Application No.: 10/669,616
Amendment dated October 17, 2005
Reply to Office Action of June 15, 2005

Amendments to the Drawings:

Remarks/Arguments

FIG. 1A
Prior Art

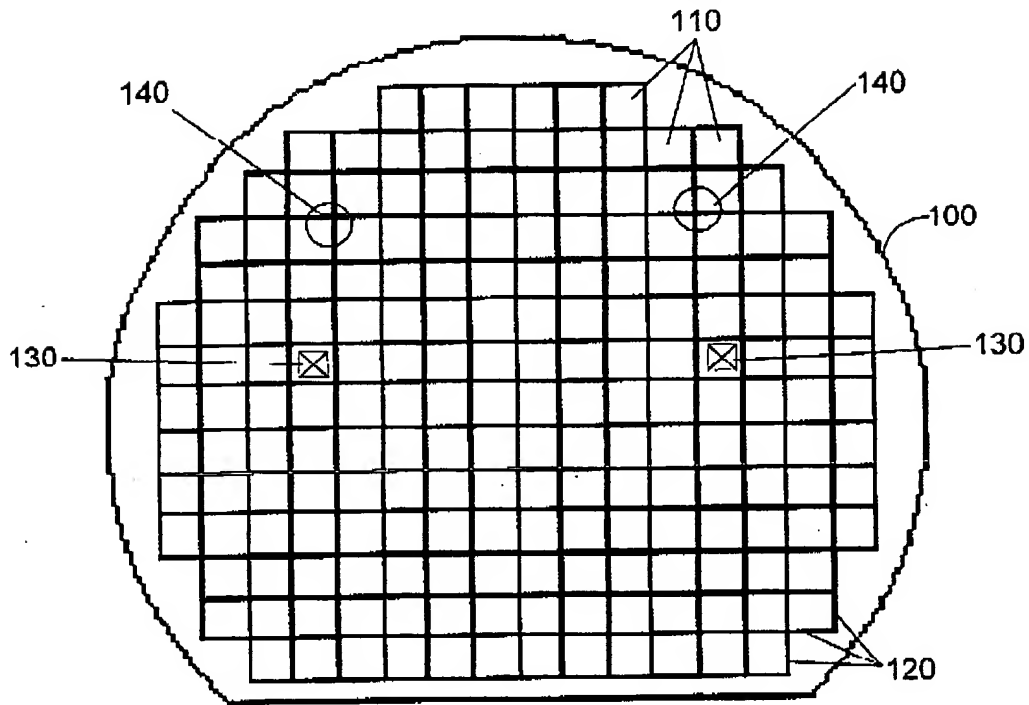
The drawings stand objected to because Figures 1A and 1B should be designated as prior art and because the original drawings do not include reference signs 309, 354, 356, 358, and 402. Amended drawings are attached which address the Examiner's objections and include reference numbers 309, 354, and 356. An additional correction has been made to FIG. 3 to include reference number 343.
